REMARKS

Annotated Marked-up Drawings

FIG. 5

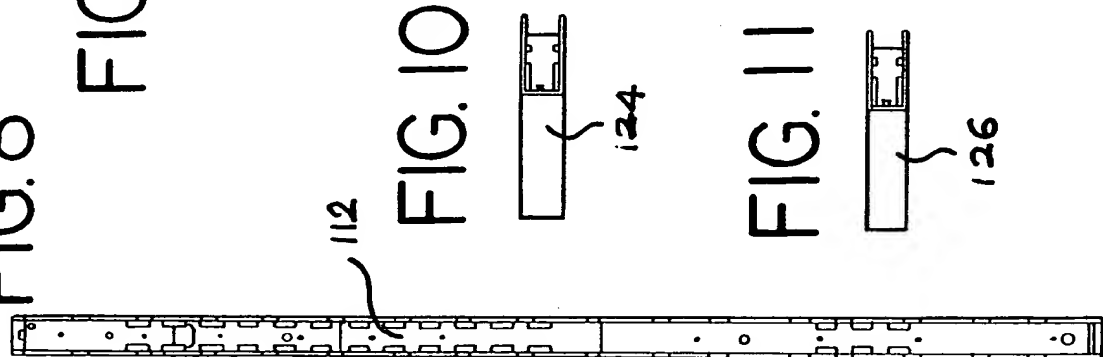
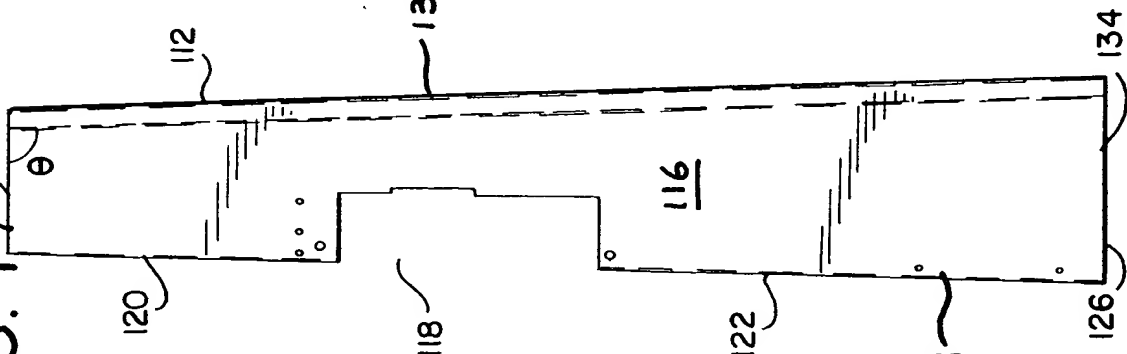
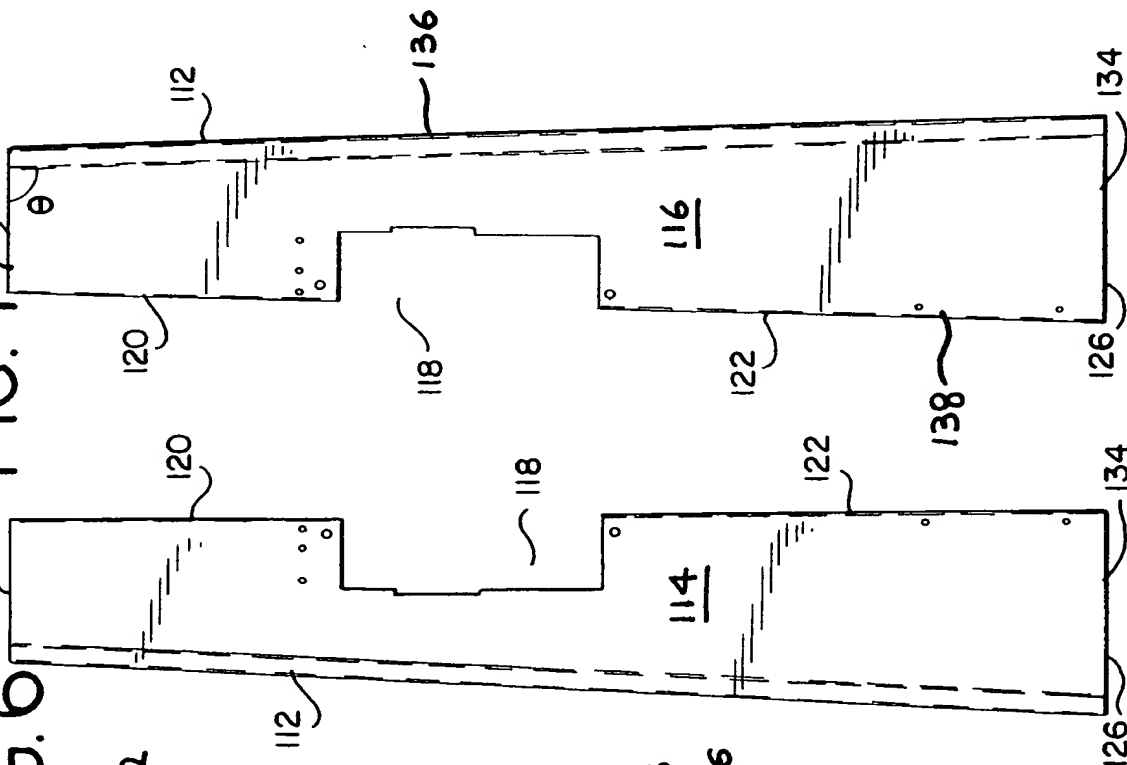
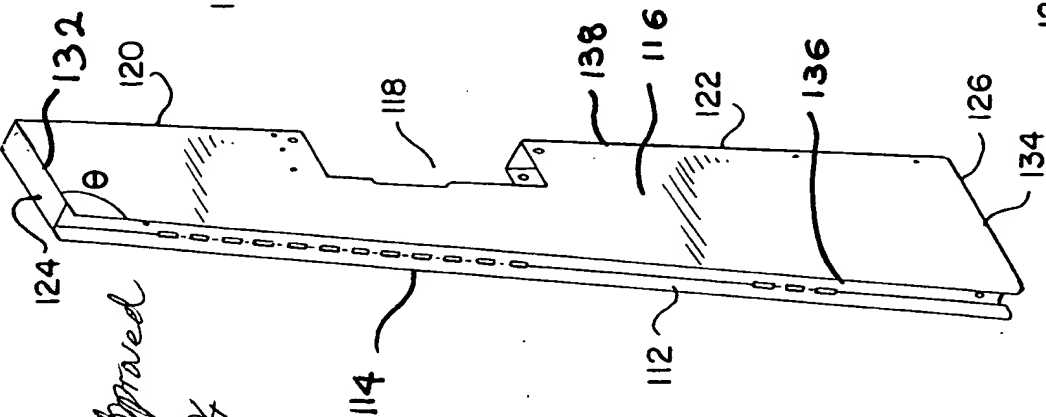
Third, the Office Action asserts that the inner wall 116 and the outer wall 118 are not identified in Figures 5-11, and that if the front wall 112 has been attached to the integral walls,

the attachment means is not described and it is not shown as a separate part. Applicants submit that the Office Action mislabels the “side wall 116” as the “inner wall 116,” “opening 118” as the “outer wall 118,” and the “front surface 112” as the “front wall 112.” Figures 5-11 have been amended to identify side wall 116. Figures 5-7 originally have identified the opening 118. Figure 9 has been amended to identify the opening 118.

Fourth, the Office Action asserts that the top stanchion surface 124 and the bottom stanchion surface 126 appear to be an upper and a lower edge of a side wall, respectively, in Figure 5. Applicants respectfully submit that the top stanchion surface 124 and the bottom stanchion surface 126 are not the edges of the side wall. Page 12, the last paragraph of the specification expressly describes that surfaces 124, 126 of the stanchion are not the edges of the stanchion as follows:

In addition, Applicants have amended Figure 5 to identify the edges 132, 134, 136 and 138 and distinguish them from surfaces. Applicants have amended Figures 5, 10 and 11 to identify the top and the bottom stanchion surfaces 124, 126. Applicants submit that top stanchion surface 124 and the bottom stanchion surface 126 indicate rectangular shaped areas, formed at the top and the bottom of the stanchion, respectively. The specification on page 11-12 describes the top and bottom stanchion surfaces as follows:
